HESS Manuscript (hess-2015-137)

Reply to comments from reviewers

Fig. 7. Mean std. dev. of annual DC values for precipitation in six climate models from 5, 10, 15, 20, and 30 year reference periods compared to far-future periods of the same length. Error bars show the range in std. dev. across the six models.

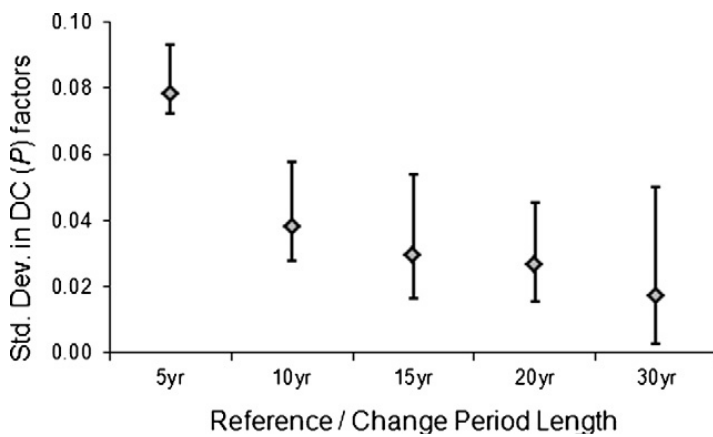
Q1: Future changes are considered by comparing two 20-year periods. While this may be sufficient for temperature changes, this might be too short if hydrological changes are considered. For precipitation, at least 30 years need to be considered to get a robust climatology as for shorter periods decadal variability may significantly impact the temporal precipitation averages over such periods, and this is usually impacting other hydrological variables in the same way, at least those that strongly depend on precipitation. In this study this is certainly the case for discharge. Thus, it should be either shown that decadal variability does not play a role in the considered region, especially for discharge, or the considered time periods need to be extended to 30 years.

*Reply:* This problem was addressed by Seaby et al. (2013) for the same geographical area as considered here. Monthly DC factors for precipitation were calculated for 5, 10, 15, 20 and 30 year periods using six different climate model data. The analysis showed that reference periods of 10 years and below had high variability between DC factors while period lengths over 15 years appeared suitable, see Figure below.

**Modifications:** The following sentence has been added to the revised manuscript: “Seaby et al. (2013) analyzed the impact of the length of the reference and the future periods and found that period lengths over 15 years appeared suitable for precipitation. Hence, comparing two 20-years periods is assumed to be adequate for the particular study area.”
